Mount Piper to Wallerawang Transmission Line Upgrade Project

Submissions Report

December 2025

Figure 5.4 Updated Figure 6.11 from EIS – Noise contours of audible corona noise in L50 conditions

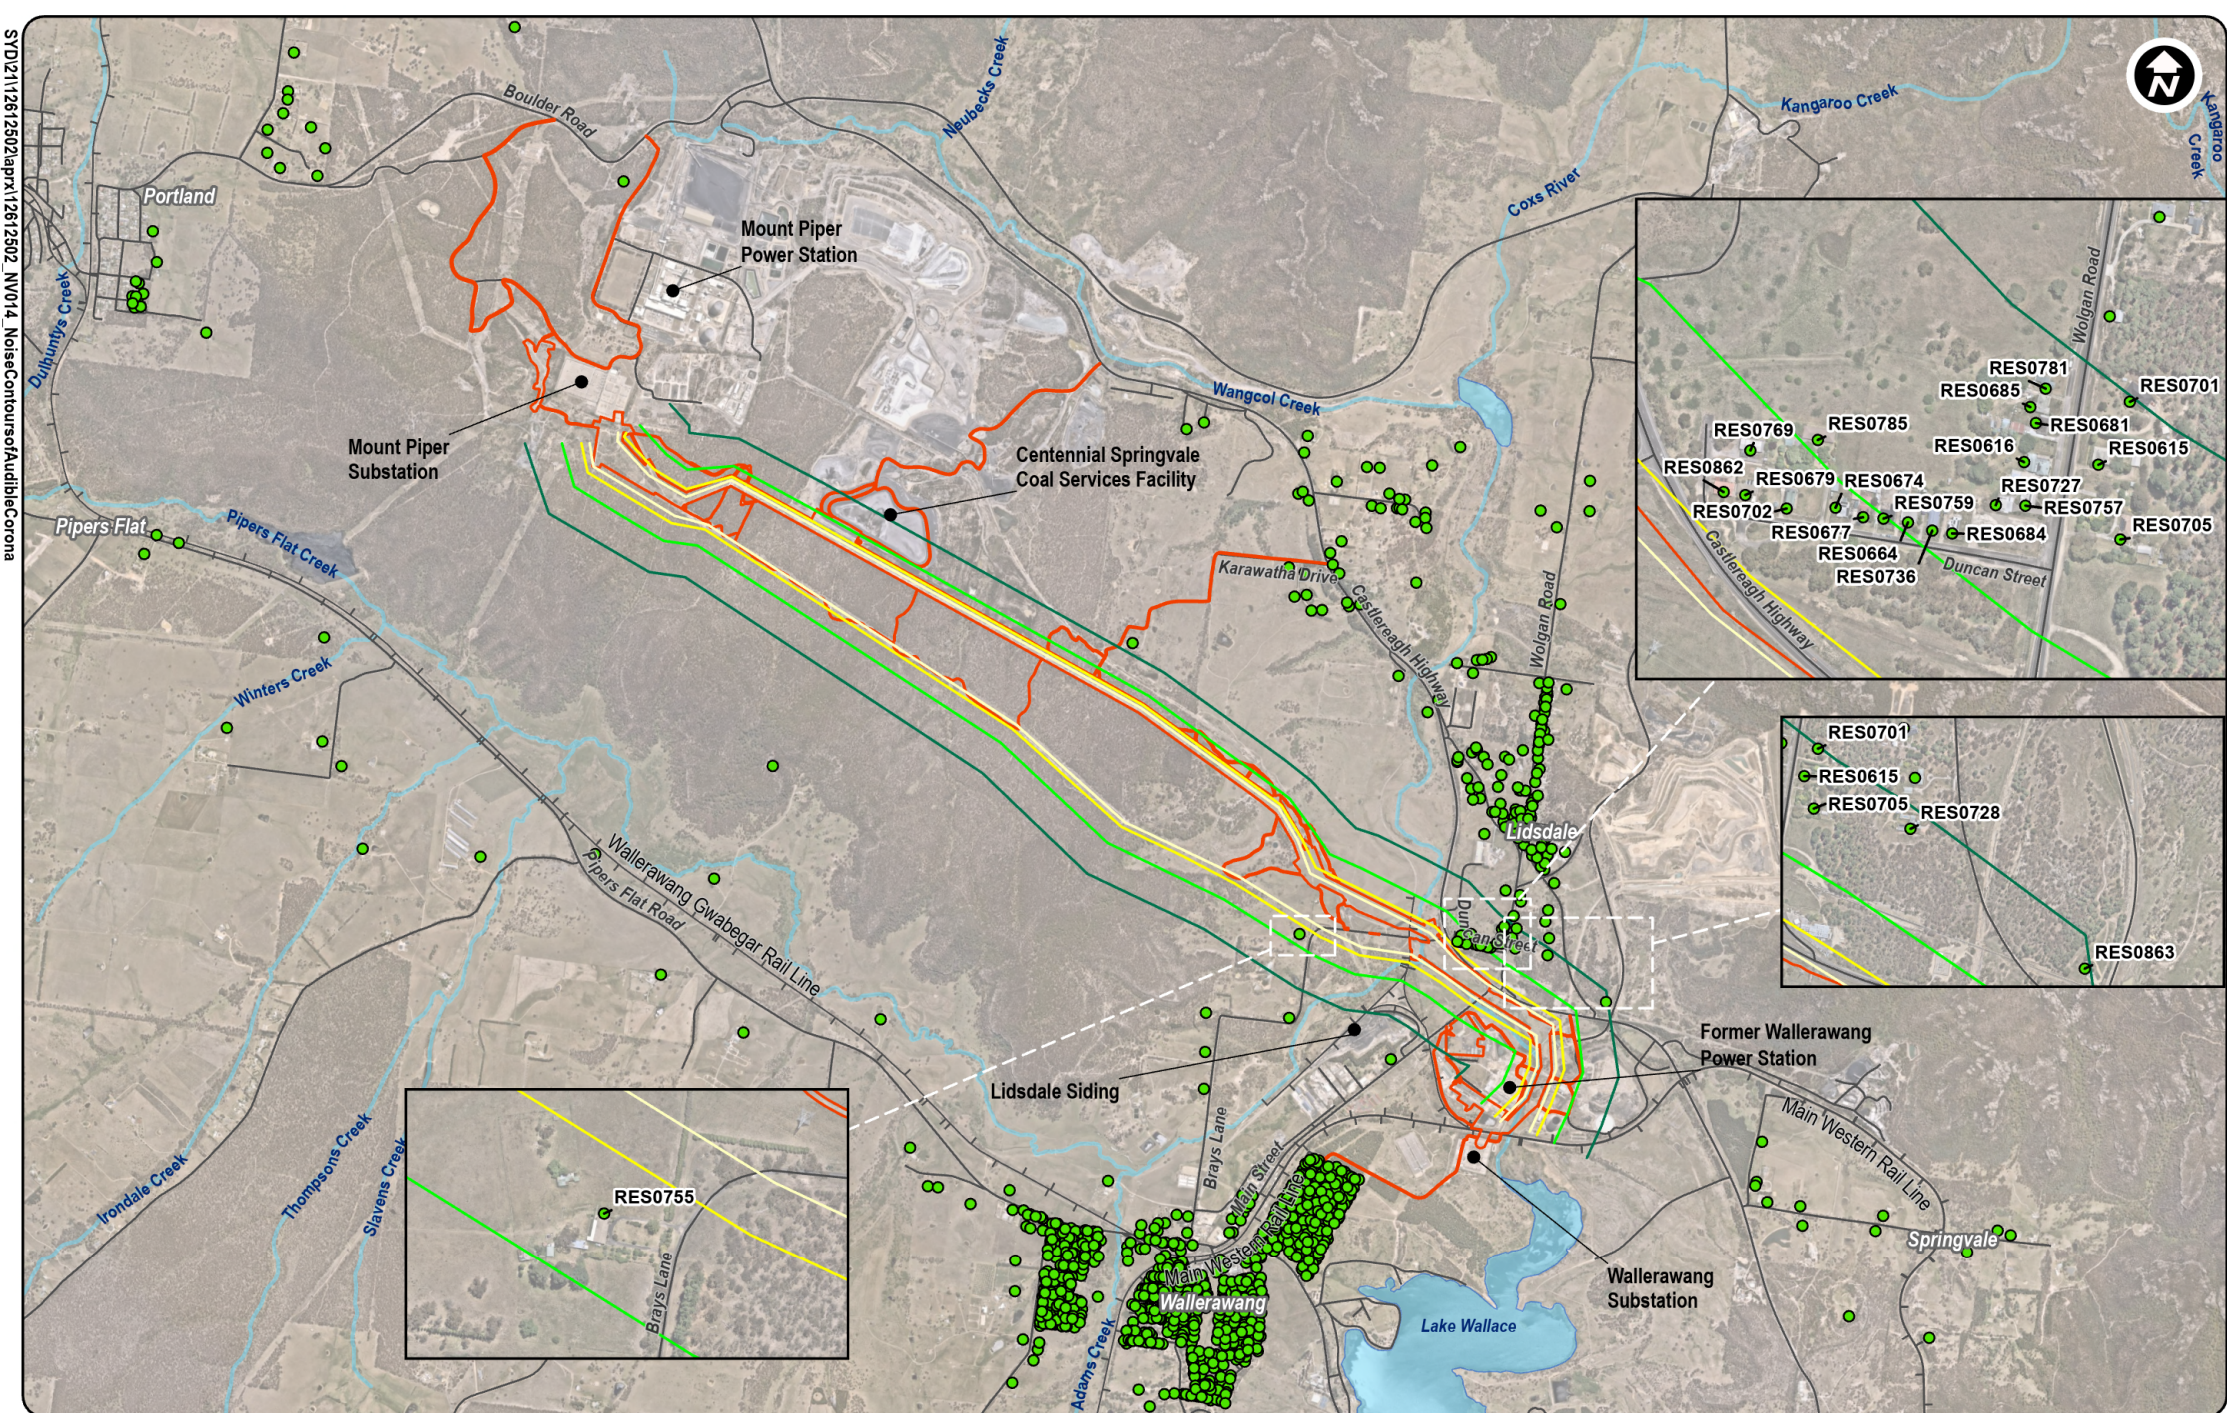
Exceedances of corona noise levels are identified at nine additional receivers compared to the existing situation. Provide anticipated noise levels at RES0863 (noting that the remaining eight receivers can be identified on the noise contour map in Figure 6.11).	Figure 6.11 from the EIS has been updated to include labelling of RES0863. This is presented as Figure 5.4 in this Submissions Report and shows the anticipated noise levels at receiver RES0863 as well as all other receivers.
Outline the change, if any, in corona noise levels at the residential sensitive receivers already experiencing corona noise.	The change in corona noise levels is described in section 8.4.2 of the EIS. The modelling suggests that of the 14 sensitive receivers that could already be experiencing potential exceedances of the assessment criterion for light rain conditions, nine receivers could be subject to an increase in corona noise of around 3 dBA as a result of the project.
